Referral Agency Response for Design and Siting Planning Act 2016

Receipt of your application deemed to be properly made on Tuesday 6 October 2020 seeking a Development Permit for Referral Agency Response (Siting Variation) to facilitate the potential construction of seven (7) new dwellings and garages within a nominated building envelope at 87 Cartwright Street Ingham, is acknowledged and its contents noted.

SR20\0015

PROPOSED SETBACKS LOTS 1&2 on RP731380 MERIDEAN: RP731380 87 CARTWRIGHT STREET

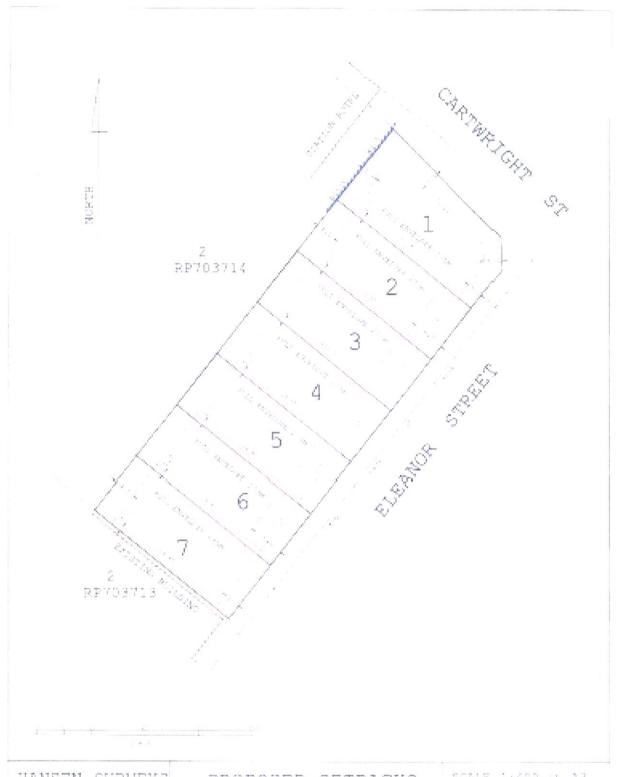
1.3	The Conditions of Approval, the re Scheme and best practice engineer					
2.	Appro 2.1	Approved Plans 2.1 The development and use of the site is to be generally in accordance with the following plans that are to be the Approved Plans of Development, except as altered by any other Condition of Approval; and					
		Plan / Document Name	Number	Date			
		Proposed Setbacks prepared by Hansen Surveys	150160/03	September 2020

8.	Building Height Any portion of a future Class 1 or Class 10a structure on the subject land within 1.4 metres of a side boundary shall not exceed 4.5 metres in height, unless otherwise approved by Council.	At all times.

9.	Setback Clearance Areas The area between the Class 1 building and side property boundary shall be kept clear of any vegetation.	At all times.
10.	Building Maintenance 10.1 Any wall within 750mm of the side property boundary must be constructed of and treated with materials that is maintenance free.	At all times.

10.2 The Class 1 building must not include any windows or openings within 750mm of a side property boundary.	
11.	Development Timing A Development Permit for any future Class 1 building can only occur following the registration of the corresponding lot approved under Development Permit (RC19\0001).	Prior to the issue of a building permit.
